Quik Trip Corporation - Vicinity of 6th Ave and University Ave 11-2013-1.02

Quik Trip Convenience Store - 614 University Ave

We have reviewed the first (1st) submittal of the site plan for the Quik Trip Convenience Store, located at 614 University Avenue in Des Moines, and have determined that the following conditions must be satisfied before plan approval can be granted.

L100

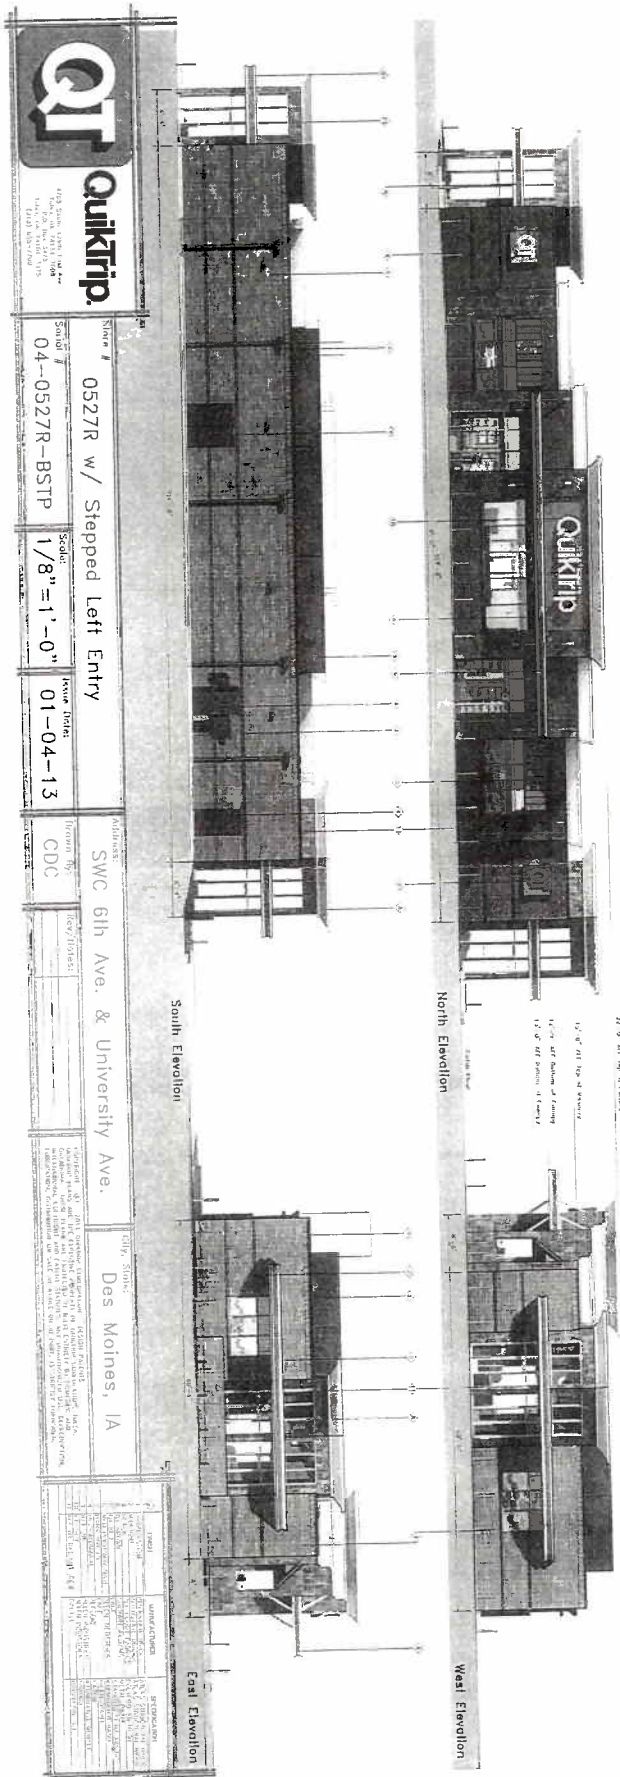
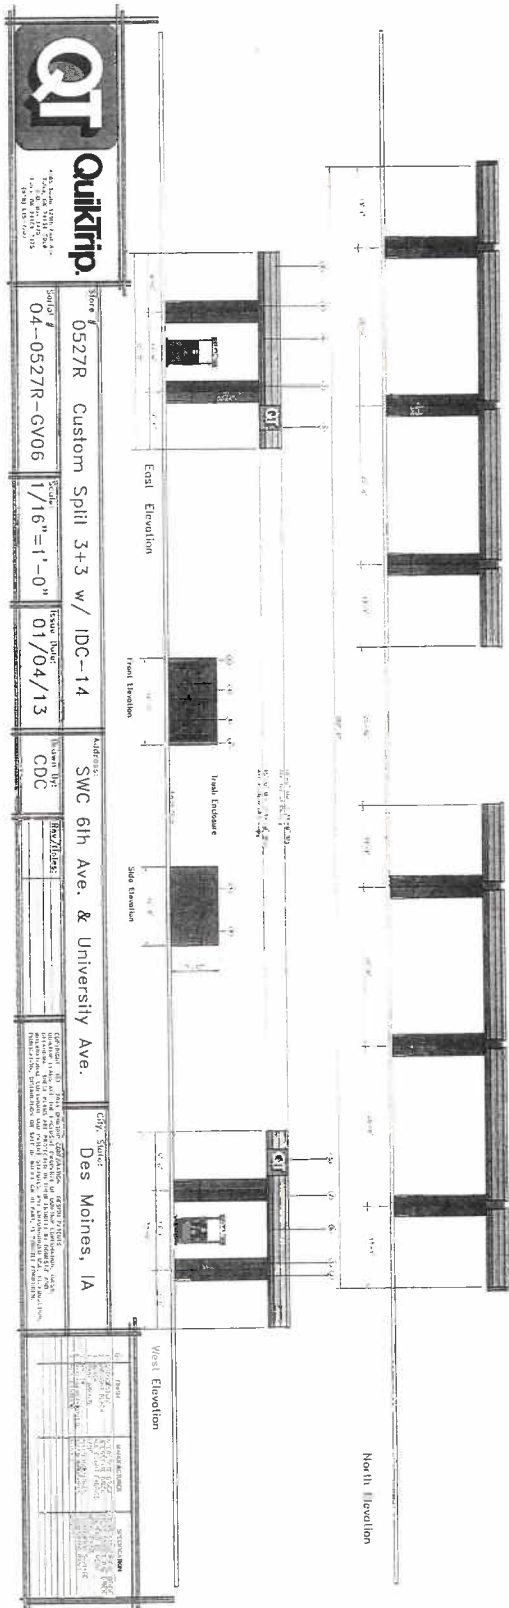
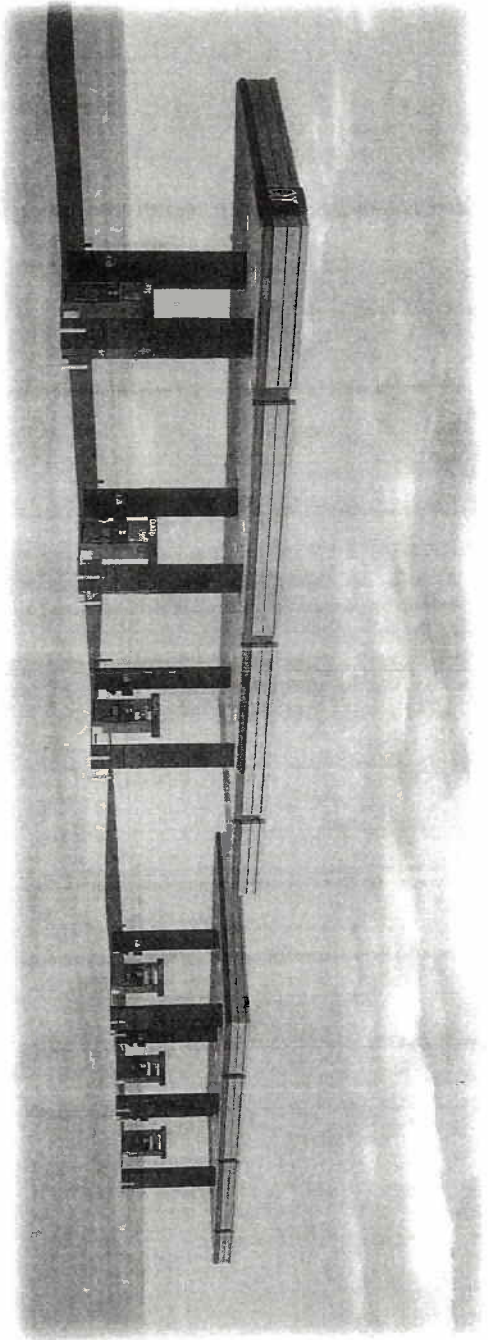
41. By staff calculation, there are a total of 12 fueling locations for this site. The open space sq. ft. calculations based on fueling locations on Sheet L100 appear to be incorrect.
